Addendum No.6
Maple Street Shelter

MAPLE STREET SHELTER
1580 Maple Street
Redwood City, CA
Project No. PC019

Issued on September 27, 2016

DEMOLITION PLAN

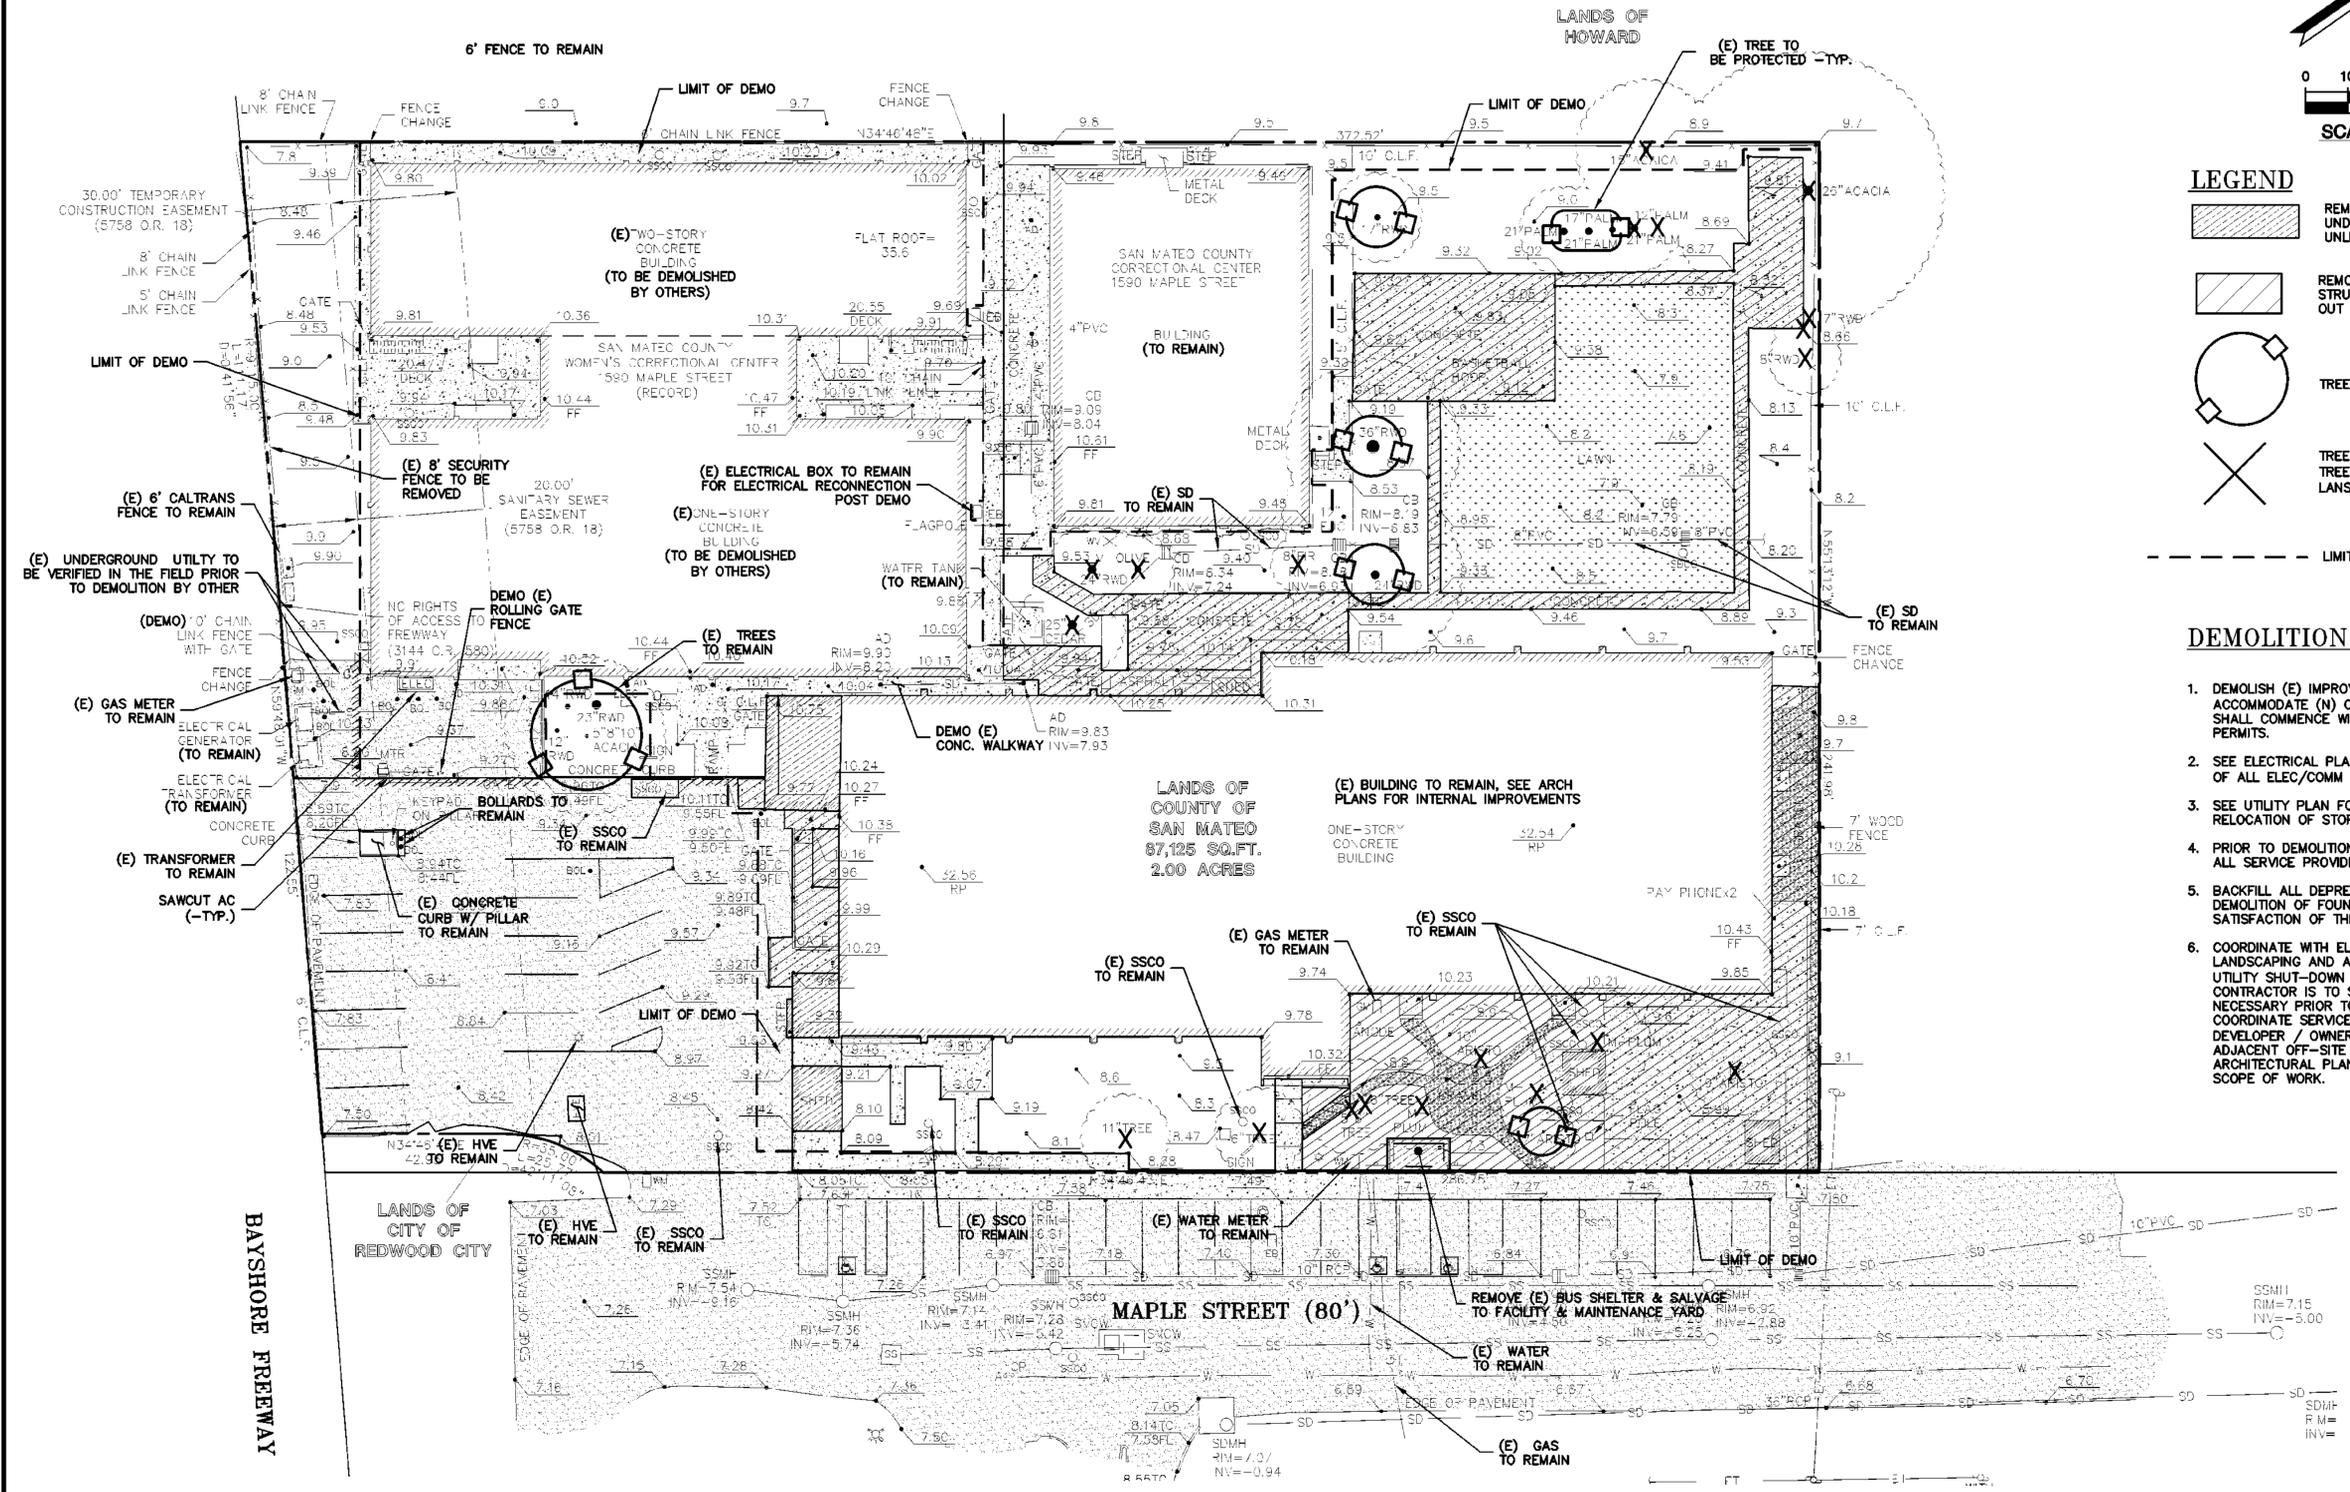
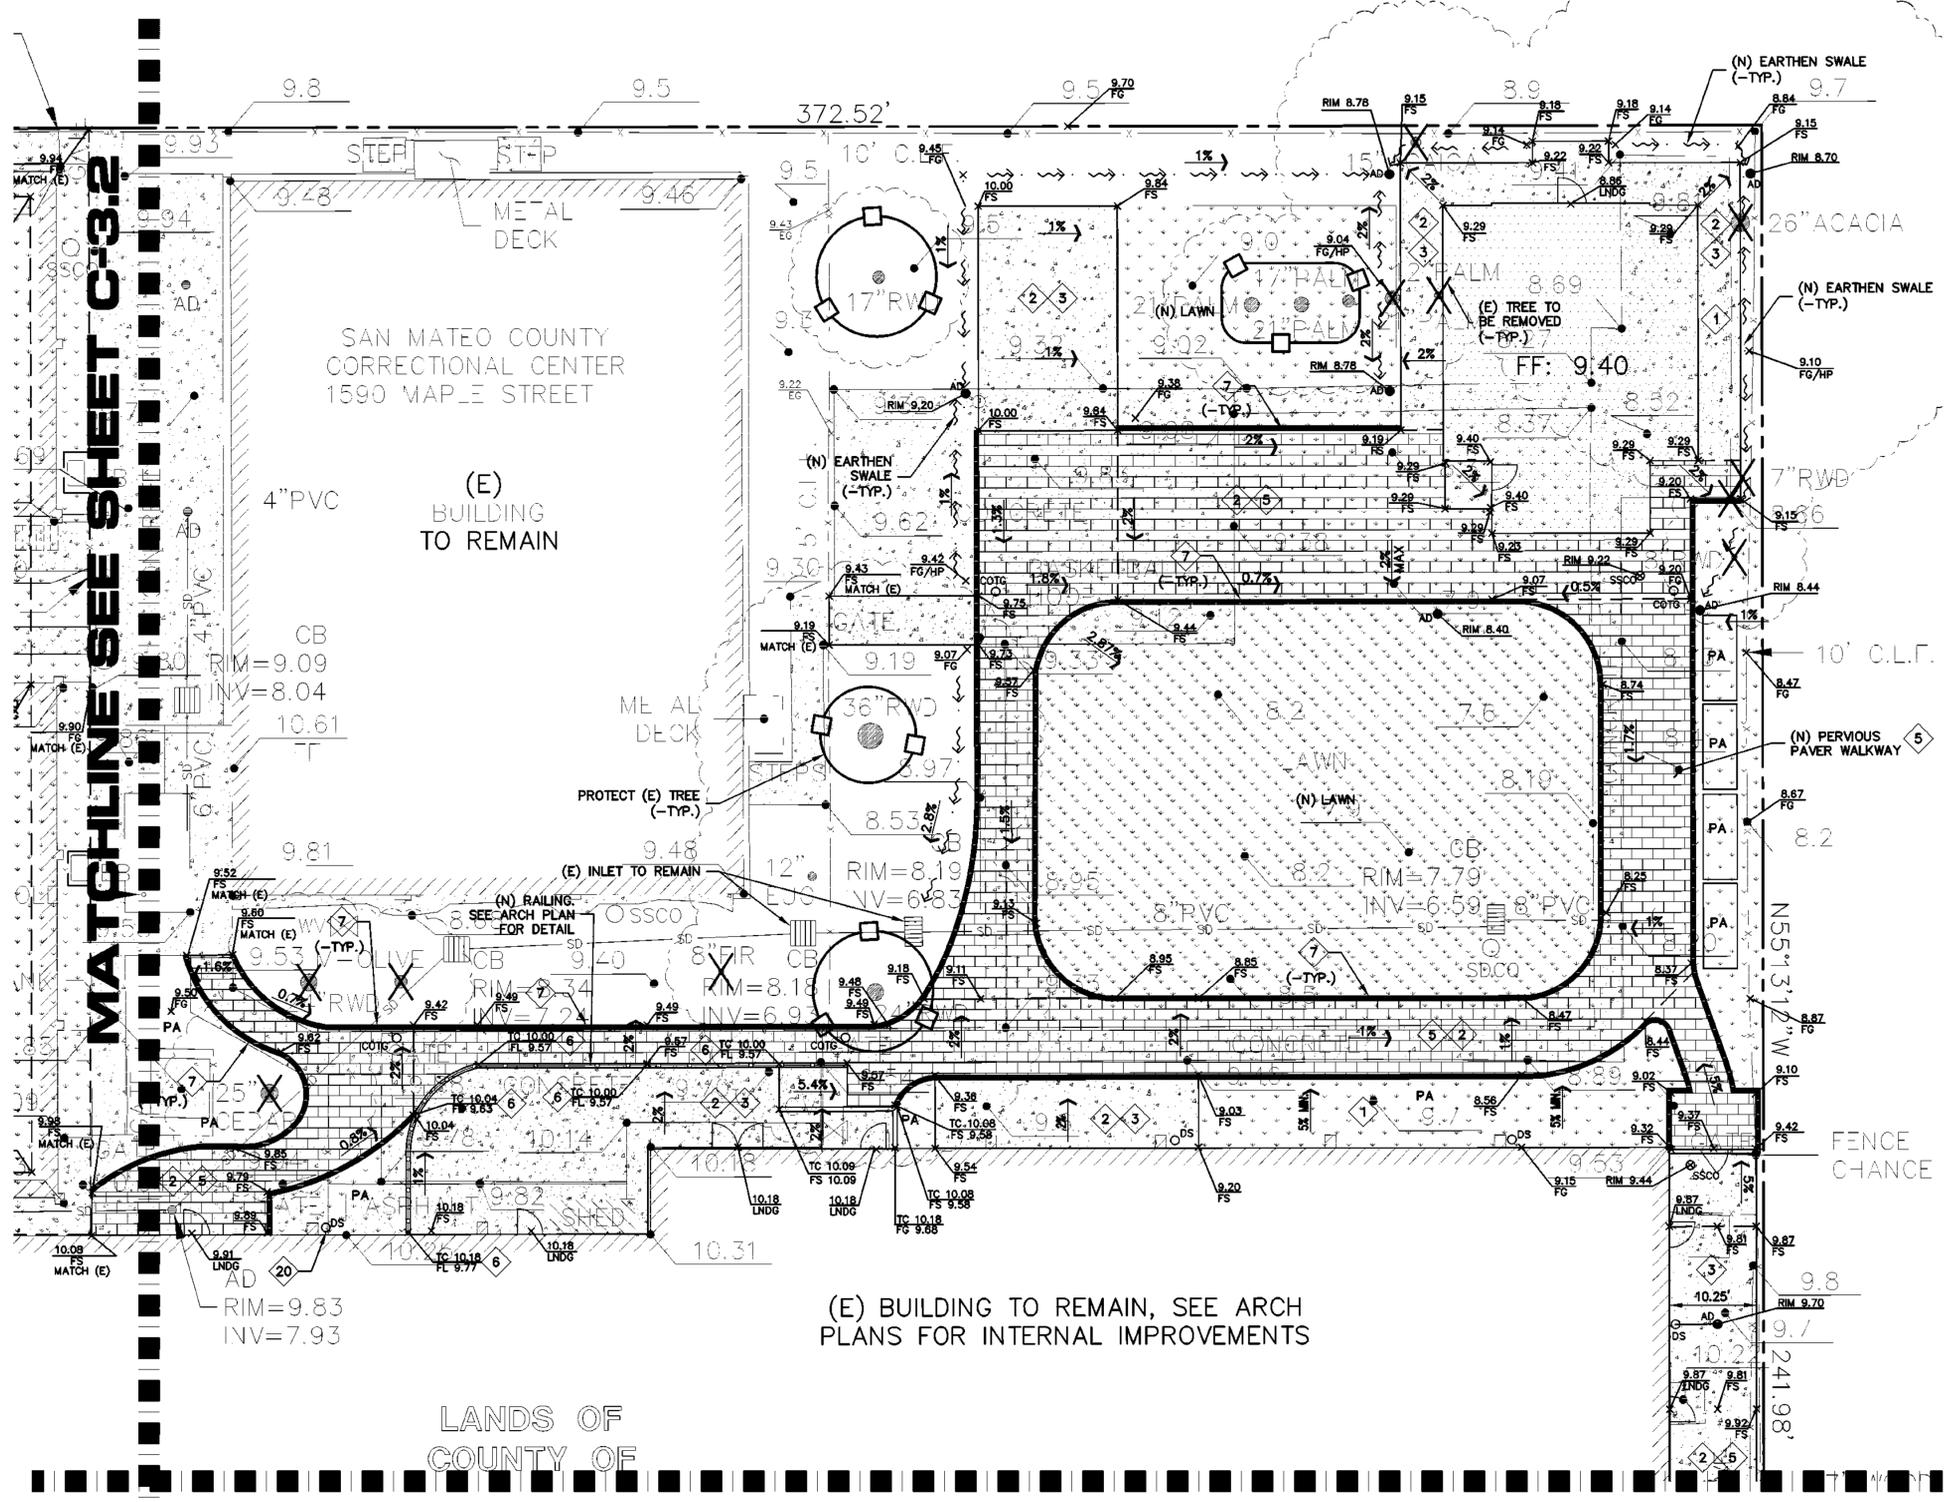
Demolish all structures shown on site plan Sheet A-1.2, remove the existing floor slab, and existing wood piles to 3' below the existing finish floor and grade the site to drain. See also additional building

**GRADING AND
 DRAINAGE PLAN**

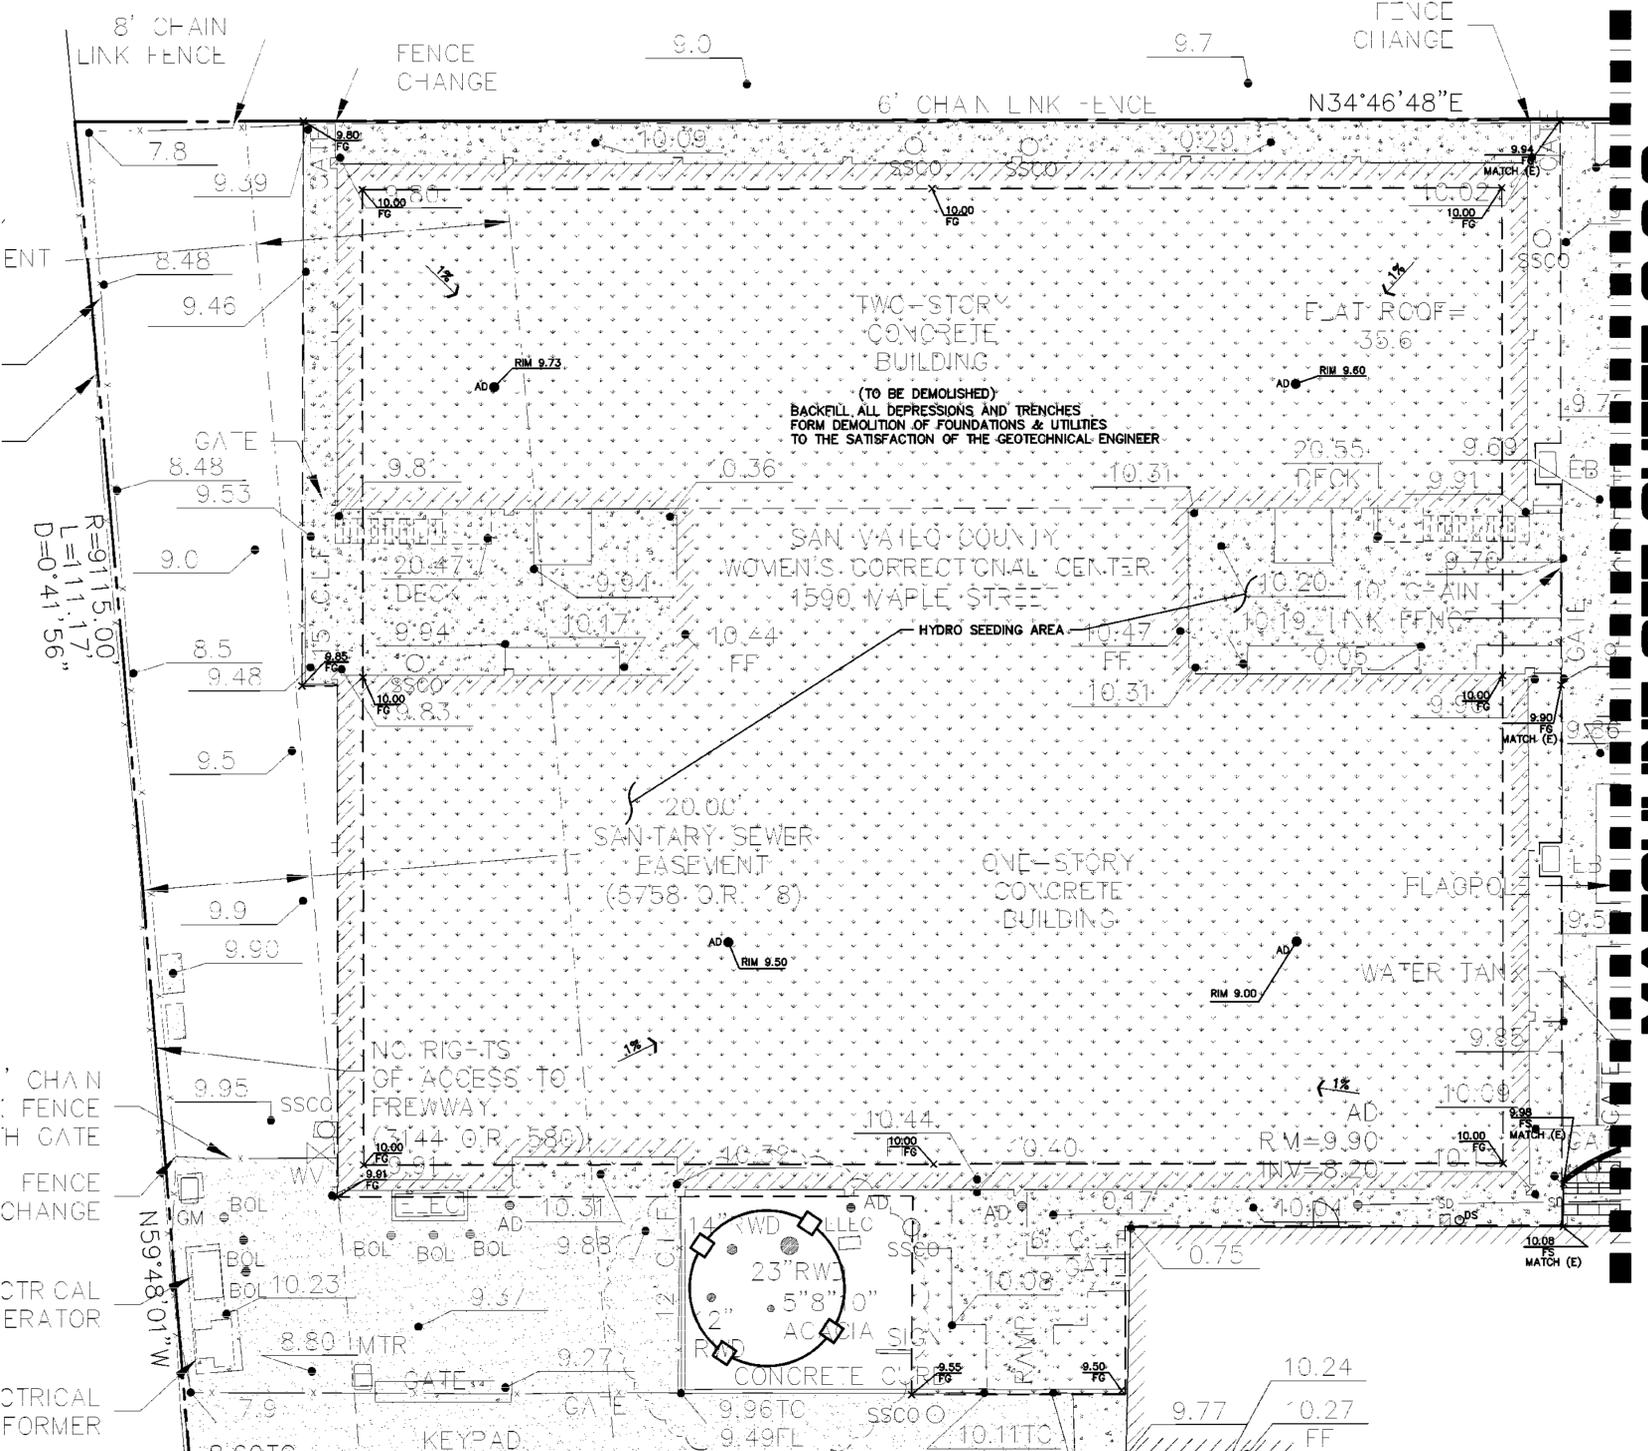
- i. Install storm drainage, grade site to drain, and hydro-seed. See civil drawings.
